Comparing the PCI2050B to the PCI2050

PCI Bus Solutions

This document discusses the differences between the PCI2050 and the PCI2050B. In general, the PCI2050 and the PCI2050B are very similar. They both support up to 9 masters on the secondary interface and they both support up to 3 delayed transactions. The main difference between the PCI2050 and the PCI2050B is that the PCI2050B supports 66MHz. Also, all errata of the PCI2050 are fixed in the PCI2050B.

Figure 1. Clock Divider

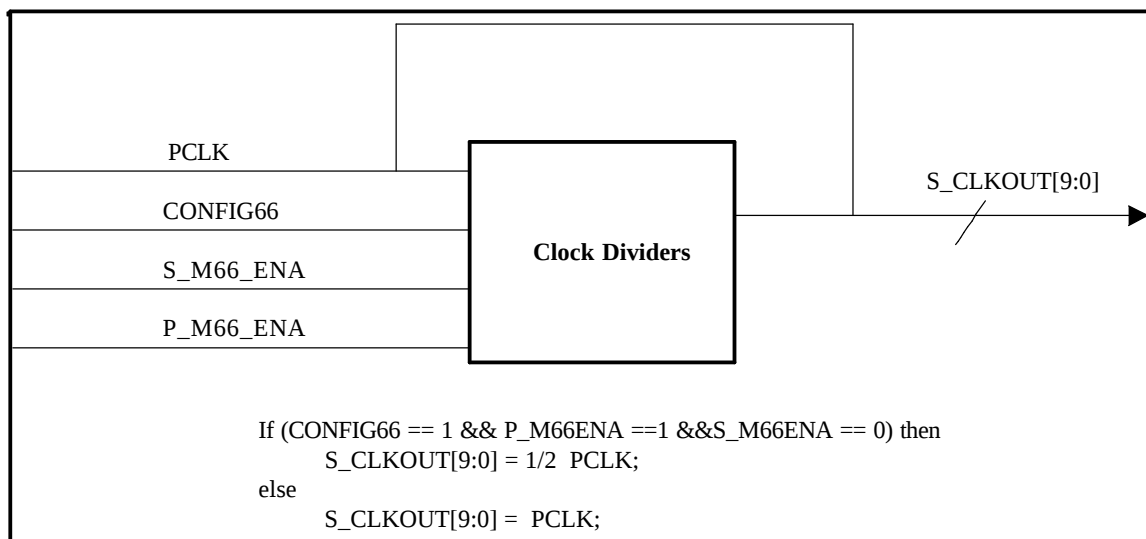
The PCI2050B does not support 33 MHz primary/66 MHz secondary bus operation. If CONFIG66 is high and P_M66ENA is low, the PCI2050B pulls down S_M66ENA to indicate that secondary bus is running at 33 MHz. The 2050B generates the clock signals S_CLKOUT[9:0] for the secondary bus devices and its own interface. It divides the P_CLK by two to generate the secondary clock outputs whenever the primary bus is running at 66 MHz and secondary bus is running at 33 MHz as shown below.
